HOMELITE **TEXTRON**

Homelite Division of Textron Inc.

BRANCH SERVICE MEMO NO. 1056

SUBJECT: Index for Branch Service Memos

CORRECT WIRING DIAGRAM

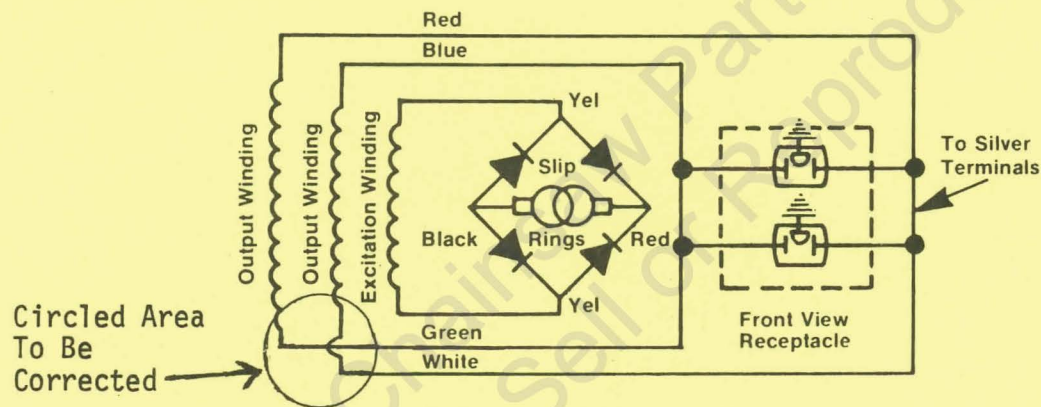
This memo is issued to correct the wiring diagram on page 6 of the above mentioned book. Below you will find a wiring diagram that has been corrected.

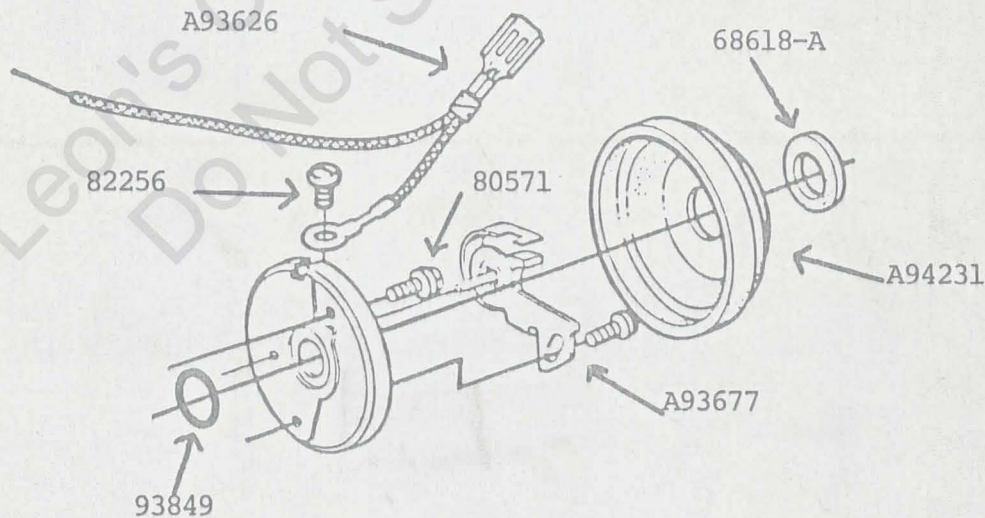
In order to improve the ignition system on the 150-AO, the system has been completely redesigned. The breaker box is now made from a more durable plastic that should not bend when fastened to the powerhead. This should virtually eliminate misalignment of the points.

The points now have a breaker plate on the bottom for more stability and easier gap setting. This new plate eliminates the need for the ground terminal part #68591-A. The entire point set will now be one piece only, instead of the two piece (breaker and post) assembly.

The stop switch lead has been redesigned to eliminate all soldering. Also, with the redesign no wires will lie between the breaker box and powerhead. The lead wire going from the switch to the junction box will lie under the high tension lead clamp.

Below you will find and illustrated parts list of the new ignition system. All parts shown are contained in kit #A69533-A.

Breaker box A69533-A includes seal #93849, cover #A94231, plastite screws #82256 breaker points #A93677 and switch lead #A93626.

ADJUSTING THE METERING LEVER
ON HDC TYPE CARBURETORS

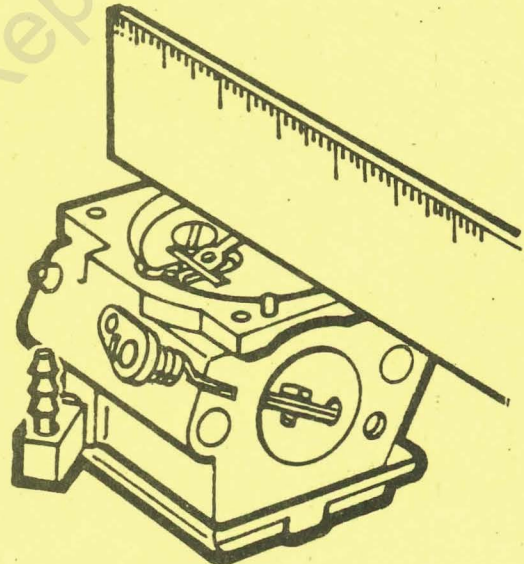
Metering levers that are set too high can cause flooding. Those set too low can cause the saw to run lean. Be sure to make the adjustments as close to optimum as possible for best results.

1. Make sure the metering lever spring is seated in its hole in the chamber floor and under the dimple in the metering lever.
2. Place a straight edge across carburetor body casting, as illustrated. Metering lever should just touch the straight-edge. Slight pressure will bend needle valve end up or down.
3. Put gasket between metering diaphragm and carburetor body when reassembling.
4. Special care should be taken to make sure that the metering lever is assembled to the hook on the inlet valve to prevent malfunctioning of the carburetor.

ADJUSTING THE METERING LEVER
ON SDC TYPE CARBURETORS

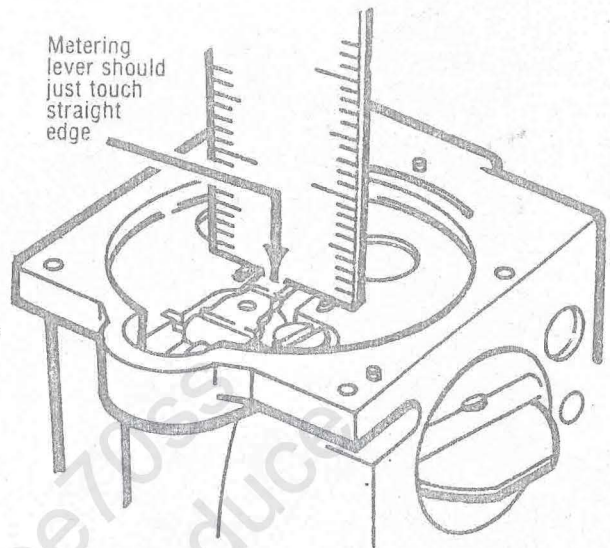
1. Make sure the metering lever spring is seated in its hole in the chamber floor and under the dimple in the metering lever.
2. Place a short straight-edge across two bosses on the chamber floor as illustrated. Metering lever should just touch the straight-edge. Slight pressure will bend needle valve end up or down.
3. Put gasket between metering diaphragm and carburetor body when reassembling.
4. Special care should be taken to make sure that the metering lever is assembled to the hook on the diaphragm and the inlet valve to prevent malfunctioning of the carburetor.

ADJUSTING THE METERING LEVER ON WB
TYPE CARBURETORS

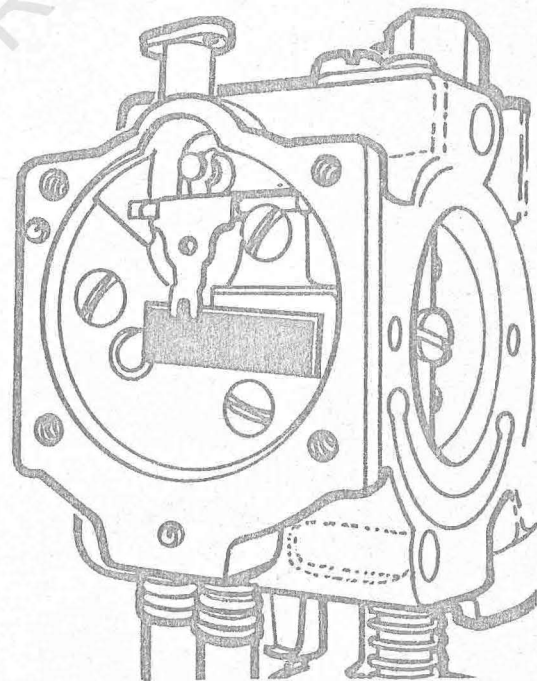
1. Make sure the metering lever spring is seated in its hole in the chamber floor and under the dimple in the metering lever.
2. Place a short shim of .012 in. thickness (#24306) on top of circuit plate as illustrated. The bottom of the metering lever should just touch the top of the shim. Slight pressure will bend needle valve end up or down.
3. Put gasket between metering diaphragm and carburetor body when reassembling.
4. Special care should be taken to make sure the metering lever is assembled to the hook on the diaphragm and the inlet valve to prevent malfunctioning of the carburetor.

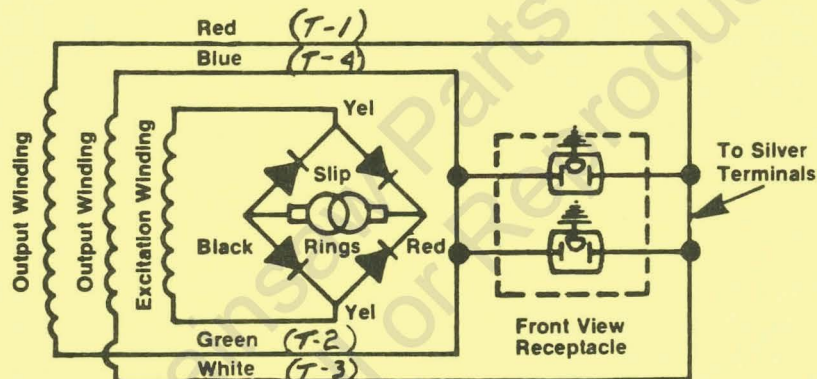
Owners manual part number 17173 calls for conversion kit number A-50693-B for converting the E-3000-1 to 240 volts. In this kit there is an instruction sheet #24501-C. Refer to wiring diagram-set number 3 of the instruction sheet when converting this unit.

You will find that the wires illustrated in the instruction sheet are color coded and the wires in the E-3000-1 are number coded. Below is a wiring diagram that is both color and number coded.

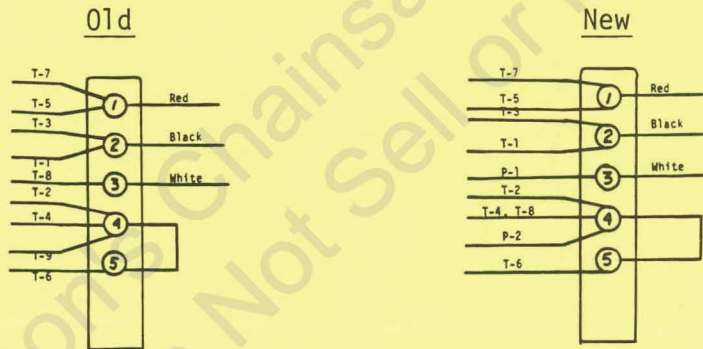
The wiring marking on the service stators have been changed for standardization. The chart below lists the old markings and the new markings.

**Figure 1**Original Assembly
(Prior to Kit A-70611)**REMOVAL OF PARTS IN PREPARATION FOR KIT INSTALLATION**

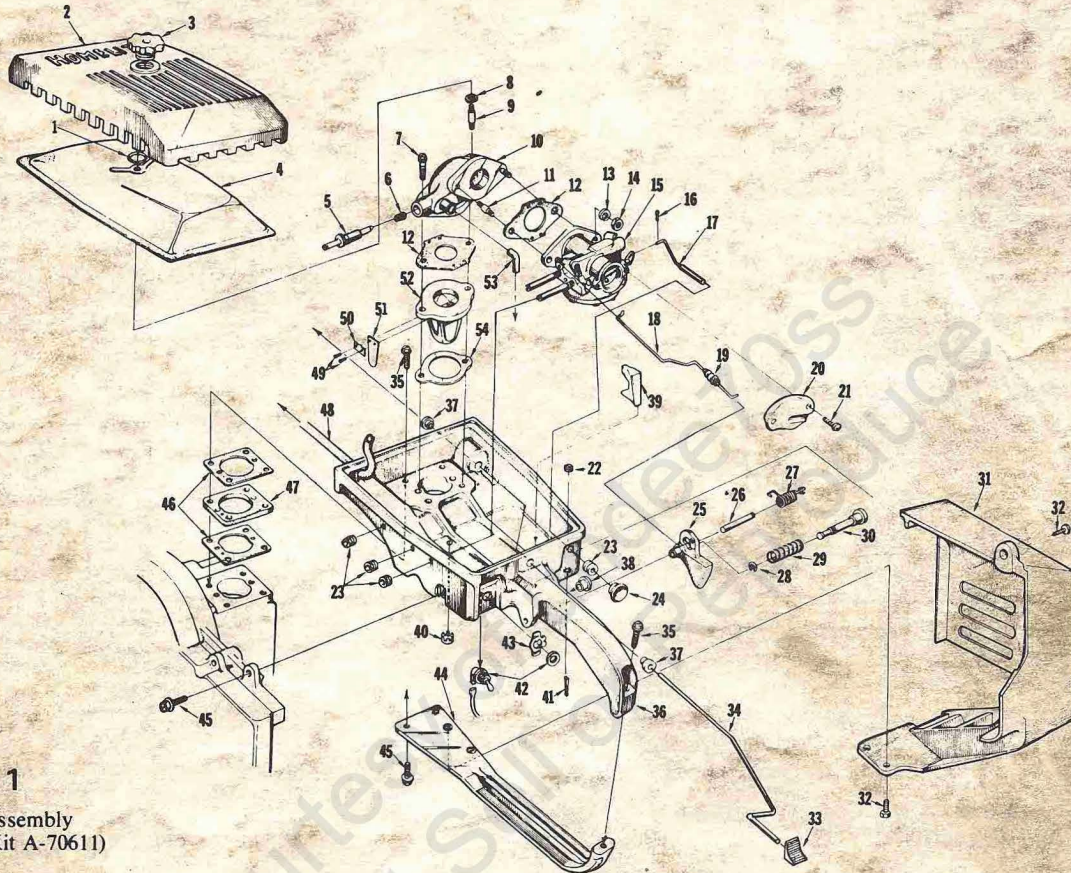
Refer to Figure 1. Remove the following parts from the unit to be modified:

KEY NO.	PART NO.	DESCRIPTION (and Remarks)	PIECES TO BE REMOVED
16	86324	PIN — cotter	1
17	A-58354	ROD — choke	1
24	57289-1	BUTTON — choke rod (will come off with the rod)	1
18	59338-A	ROD — throttle	1
7	80882	SCREW — hex, 1/4-20 x 1 1/2 (carburetor & intake manifold will come off as an assembly)	2
52	59627-1	SEAT — reed valve (do not remove reeds from the seat)	1
12	63655-A	GASKET (the one over the valve seat)	1
54	55946	GASKET — spacer adapter	1
36	A-63665	HANDLE — throttle (remove complete assembly)	1
46	58343	GASKET — spacer (remove the top one over the spacer)	1
48	55680	LINE — fuel	1
53	63656	LINE — idle fuel (was used in S 1050E)	1

Figure 2

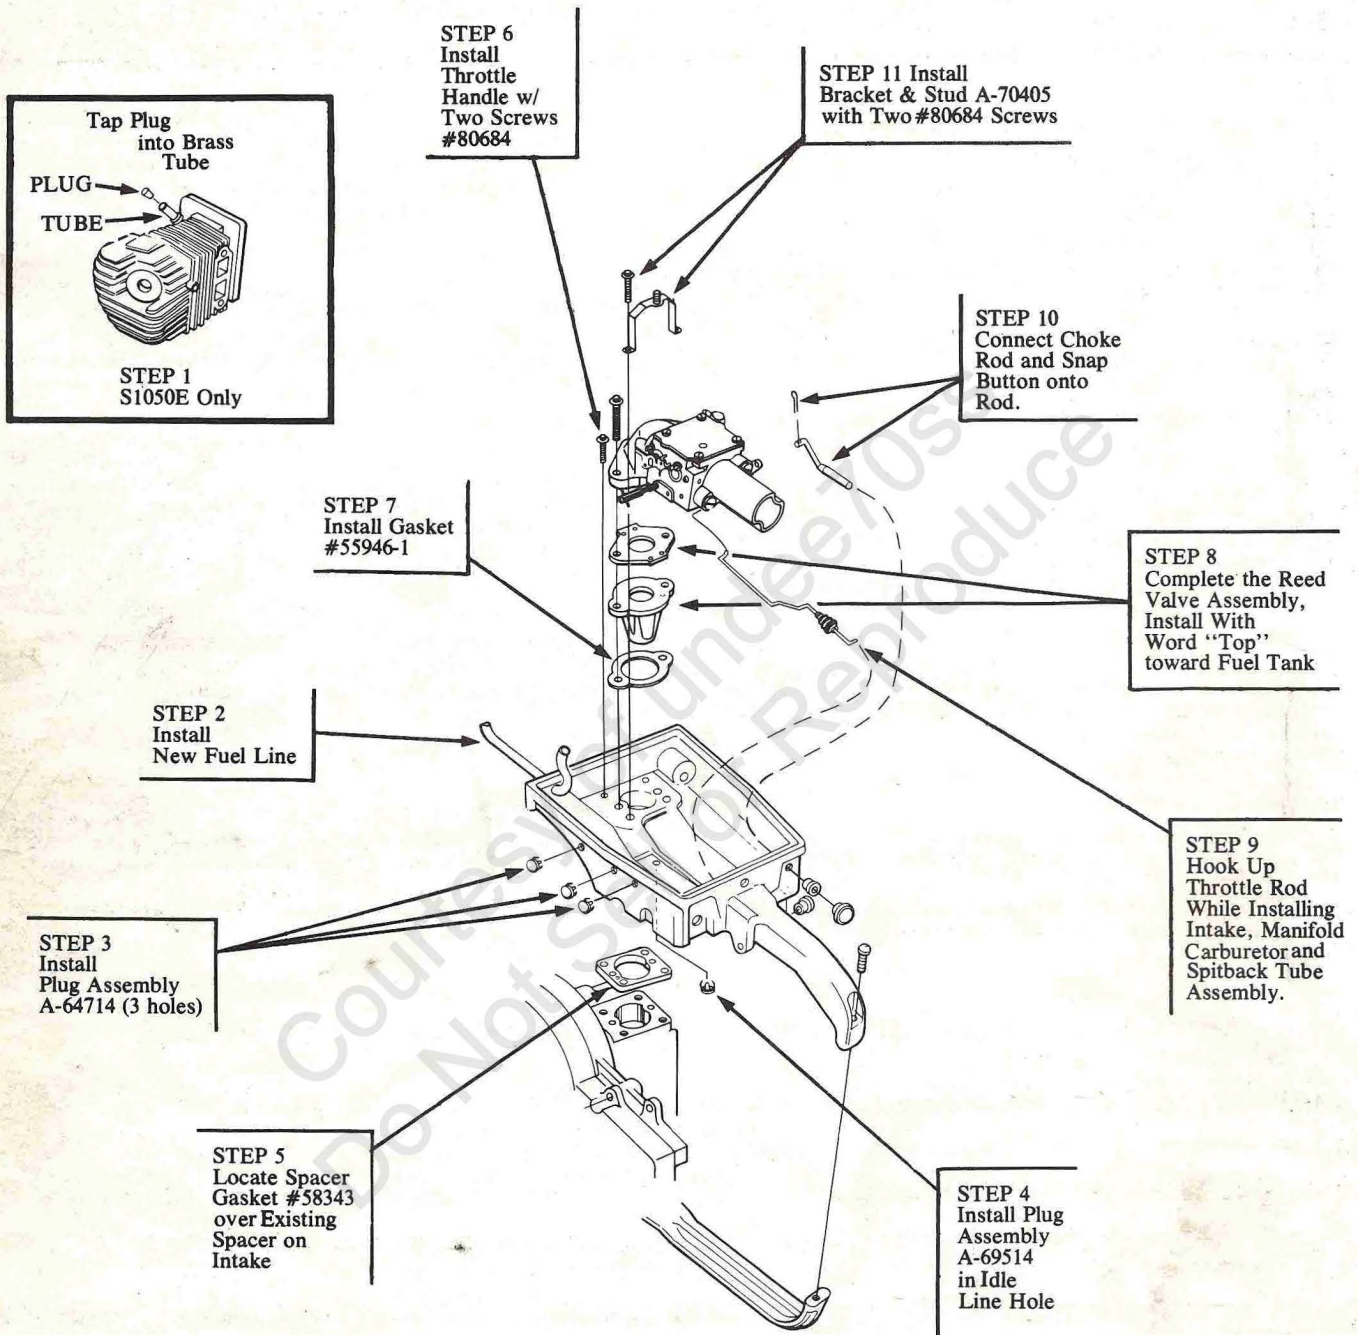
Conversion of #1050 E, S 1050A-0 & Super 1130GA0 by Installing Parts in Carburetor Kit A-70611

Put the spacer gasket #58343 (from kit) in place over the existing spacer gasket and spacer (see Figure 1). If any of these parts are not in perfect condition, change them.

Hook up the new throttle rod #70396 from the trigger to the carburetor throttle lever. Draw the fuel line into approximately correct position inside the throttle handle. Fasten the manifold in place with two #80882 hex head screws ($\frac{1}{4}$ -20 x $1\frac{1}{2}$, from unit) through the two middle holes in the throttle handle intake register face. Tighten these two screws to 70-90 pound-inches (81-103 kg-cm).

Figure 3

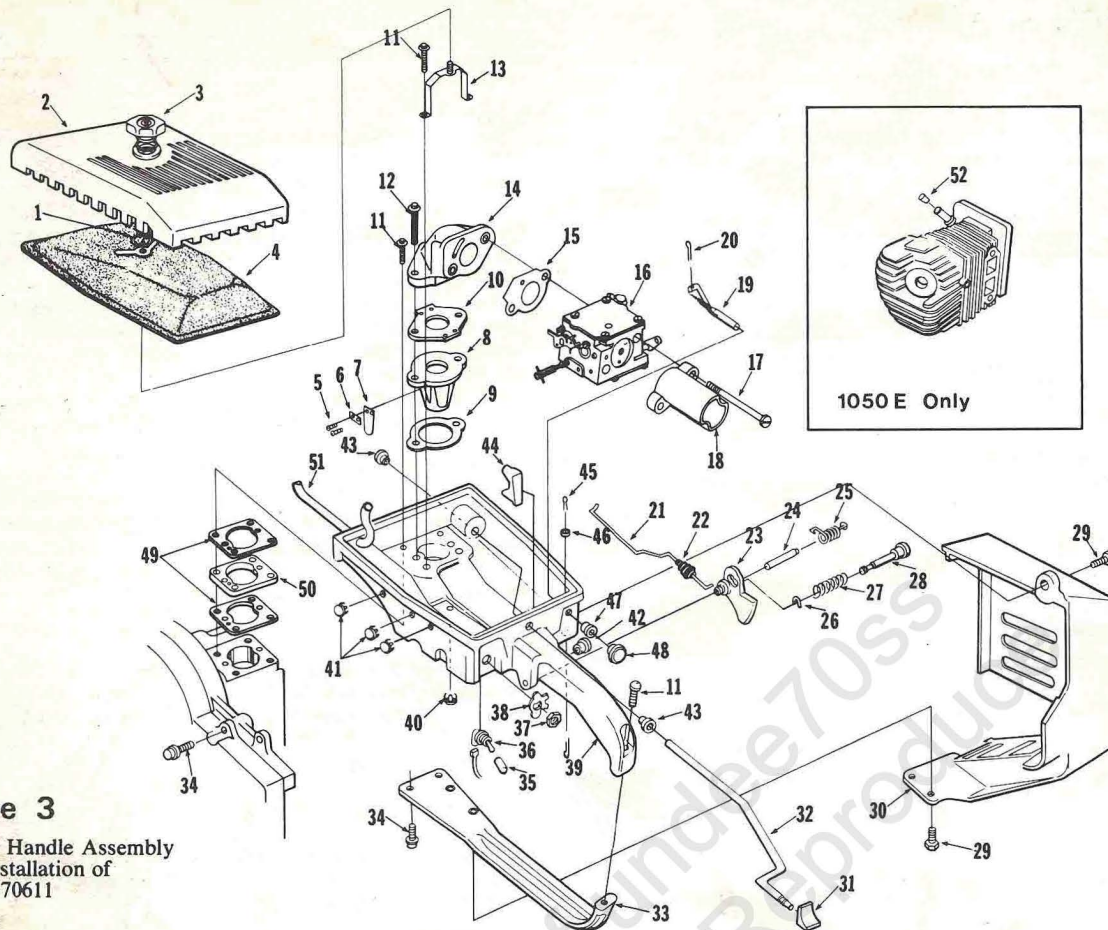
Throttle Handle Assembly
After Installation of
Kit #A-70611
